Western Sydney Green Gas Project - Response to Submissions

Jemena Gas Networks (NSW) Limited

Project Name	Western Sydney Green Gas Project - Response to Submissions
Project Number	19SYD - 13511
Project Manager	Daniel Magdi
Prepared by	Rebecca Ben-Haim
Reviewed by	Daniel Magdi
Approved by	Daniel Magdi
Status	Final
Version Number	2
Last saved on	1 May 2020

PROPOSED 19m AV ROUTE INTO SITE

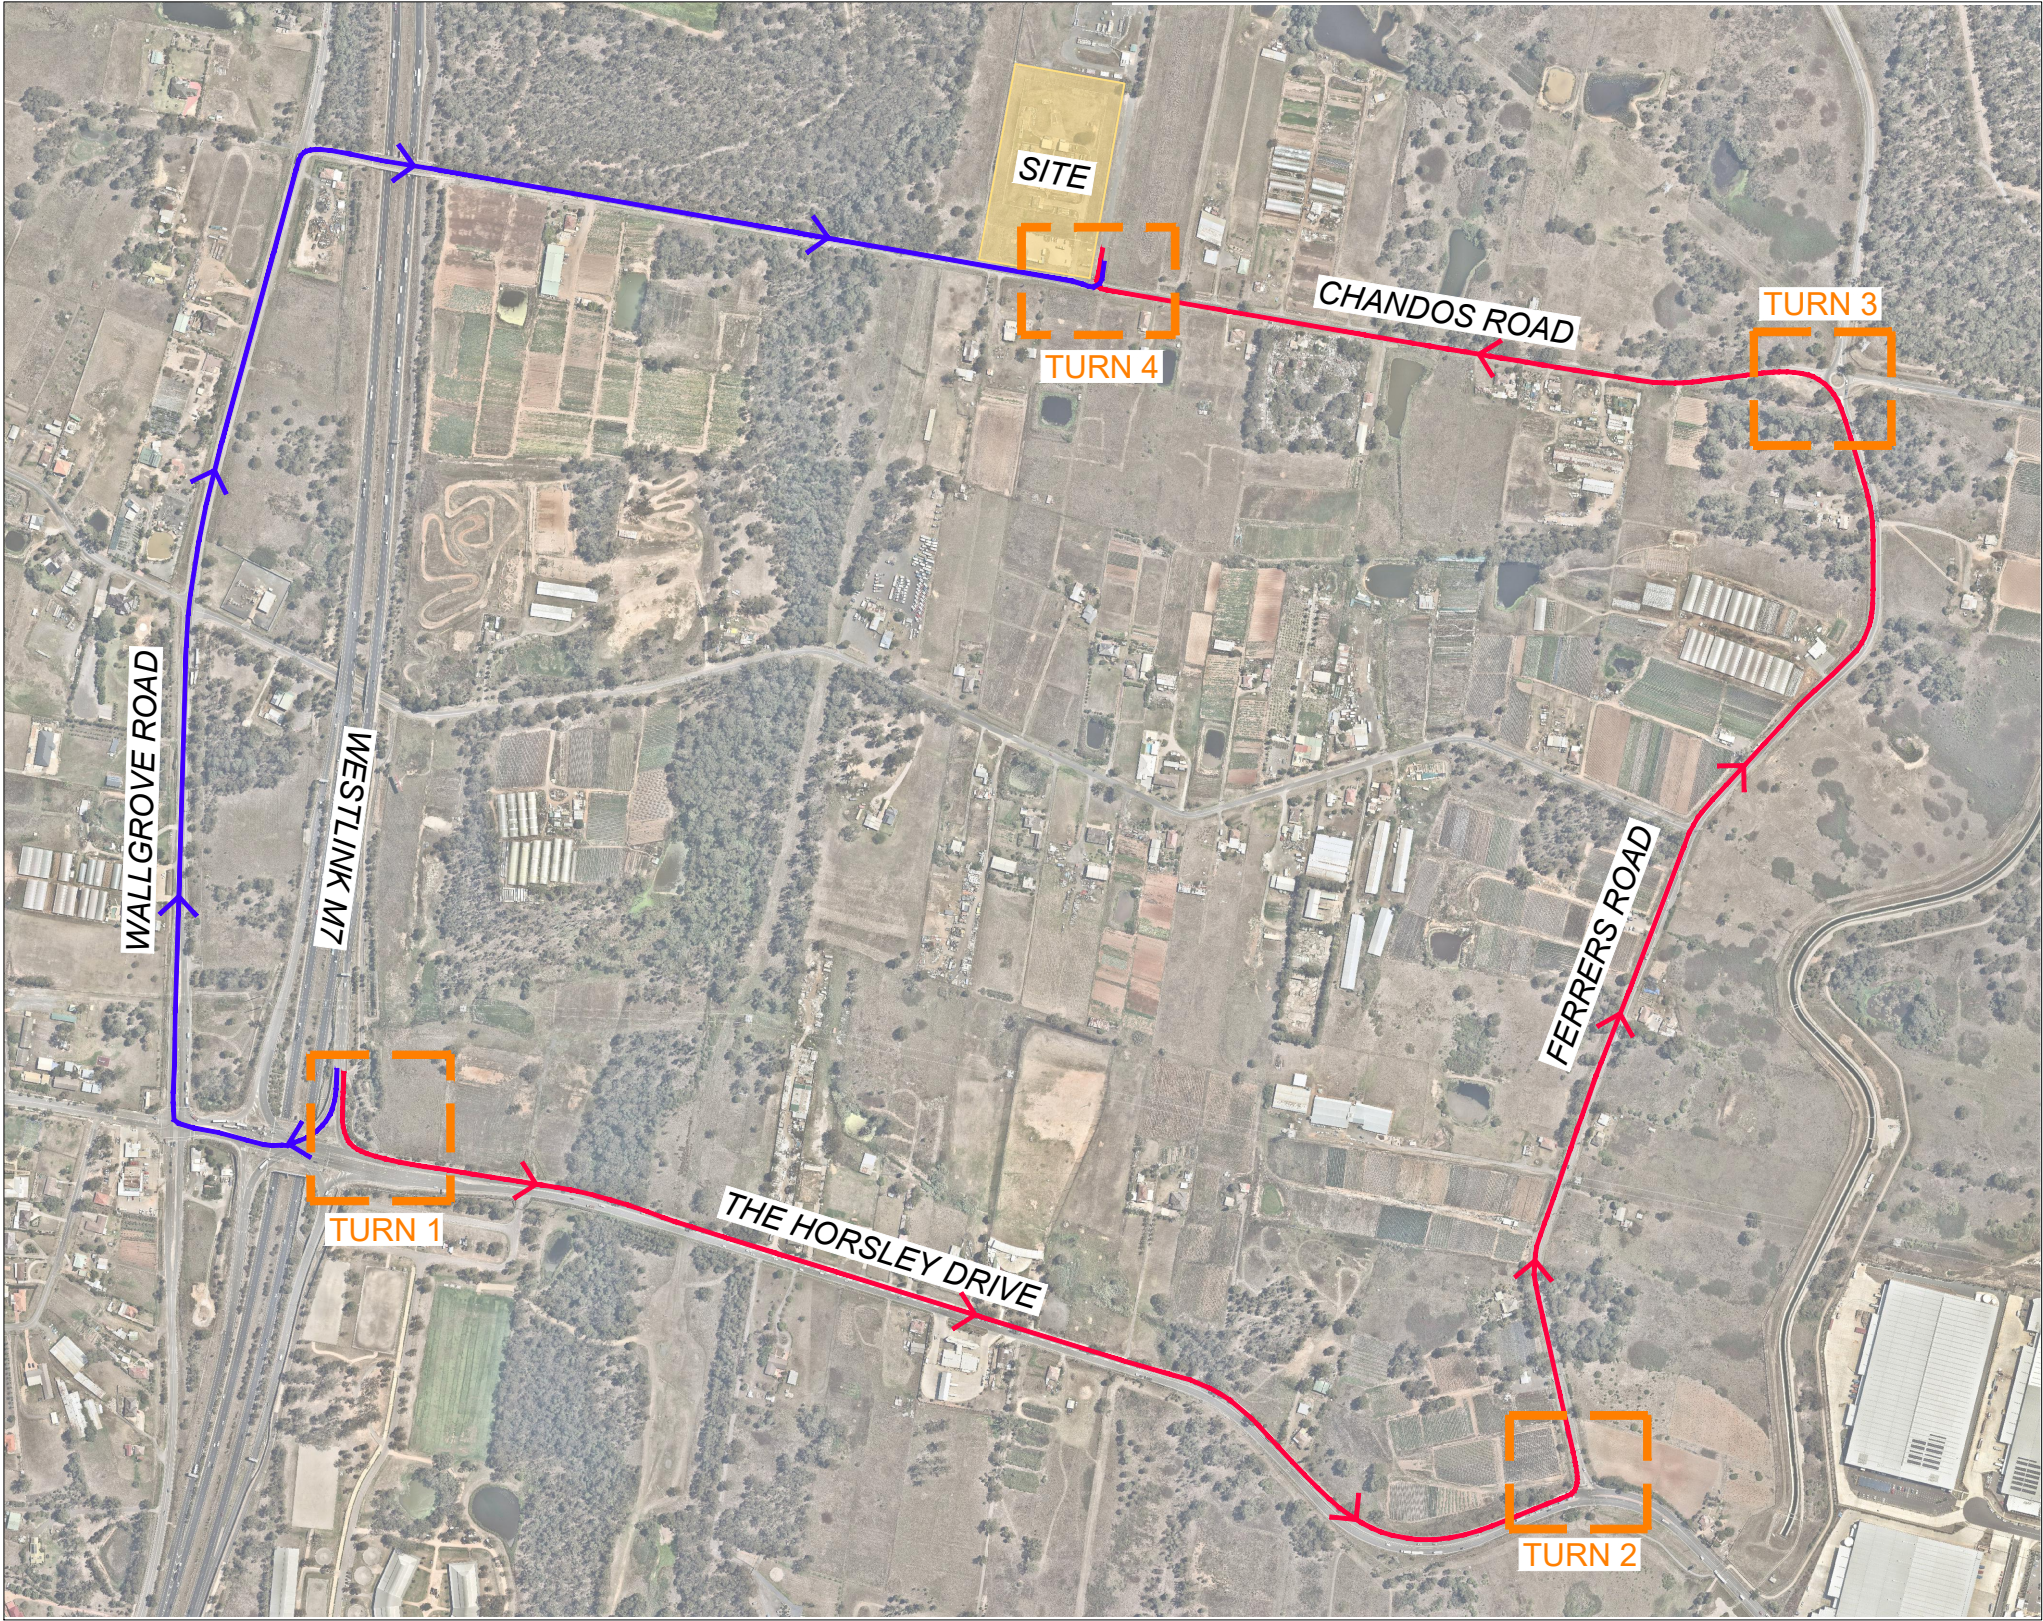
Construction Traffic Management Plan – Shall be submitted to Council for assessment. The Construction Traffic Management Plan (CTMP) shall include information such as construction vehicle routes, the type and the number of trucks, hours of operation, access arrangements and traffic control to be implemented at or near the site.

Further investigation has been undertaken by TTM Consulting Pty Ltd (2020) in regard to light and heavy vehicular movements during the construction phase of the WSGG Project. After considering the submissions from Transport for NSW and FCC regarding the safety concerns for construction traffic using the intersection of Wallgrove Road and Chandos Road, a high level Traffic Management Plan (TMP) has been prepared by TTM to outline the proposed new route for light and heavy construction vehicles to access the Site (**Appendix E**).

In accordance with the revised route, all construction vehicles will exit the M7 Motorway on to Horsley Drive, travel eastbound turning left towards Ferrers Road, travel northbound on Ferrer's Road turning left on to the Chandos Road and turn right into the WSGG Project access road. Furthermore, a swept path analysis (**Appendix E**) has been undertaken by TTM for the intersections along this revised route, with no foreseeable issues arising from heavy vehicles utilising these intersections.

The revised route for construction vehicles negates the need to further analyse the overpass over the M7 along Chandos Rd, as this route will no longer be used by heavy vehicles to access the site.
